Response to Submissions Report

State Significant Development – SSD 9912

Roseville College – New Sport and Wellbeing Centre Development

27-29 and 37 Bancroft Avenue, Roseville

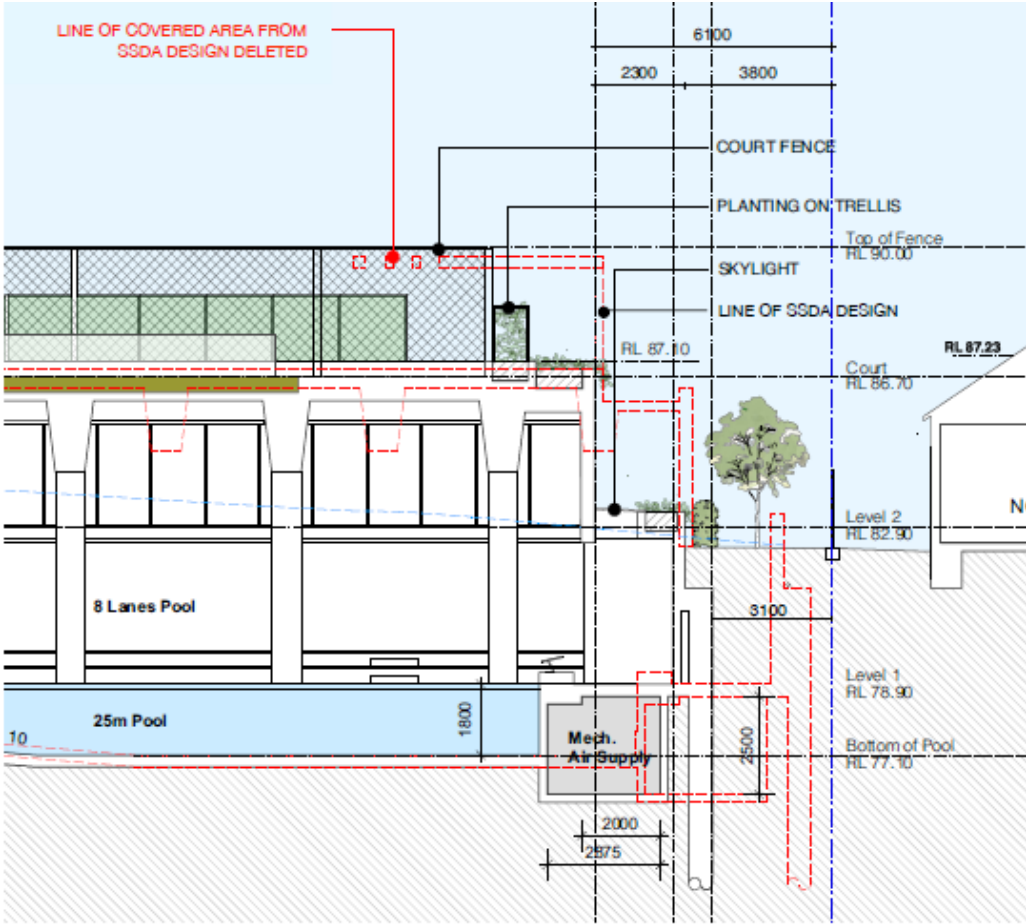
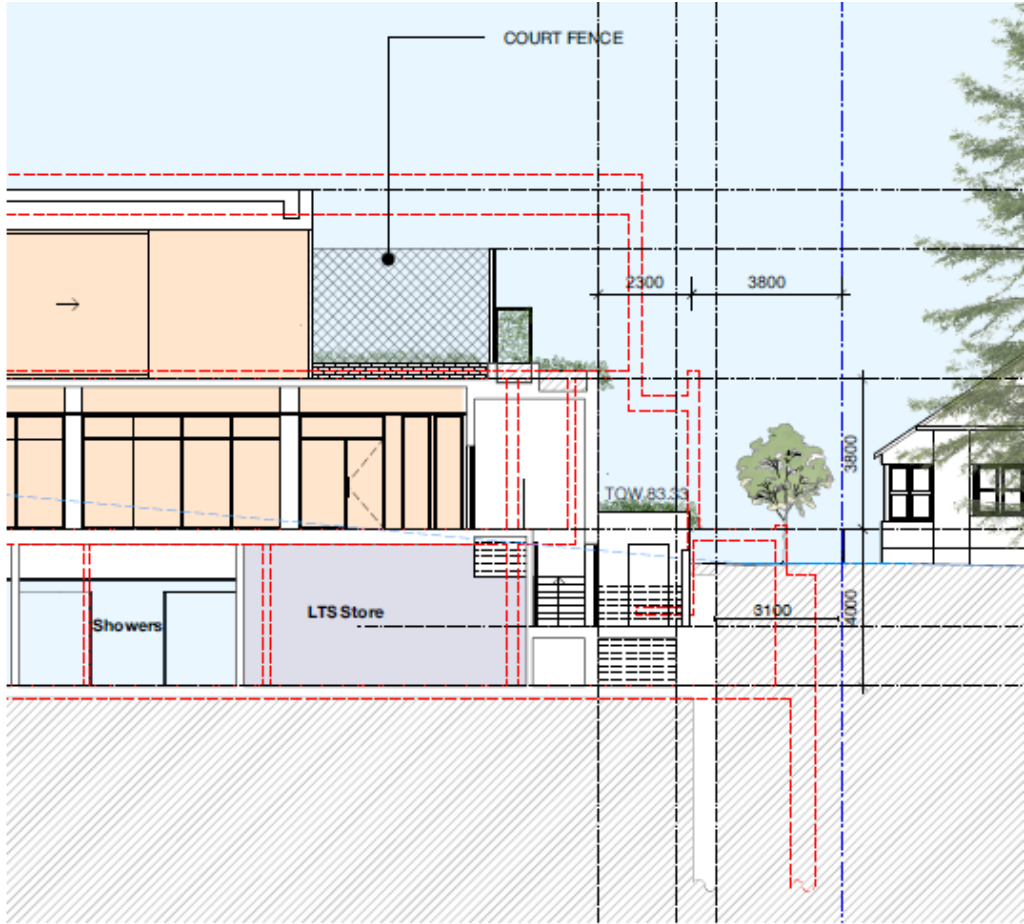
<p>Summary of Landscaping issues raised:</p> <p><u>Trees</u></p>
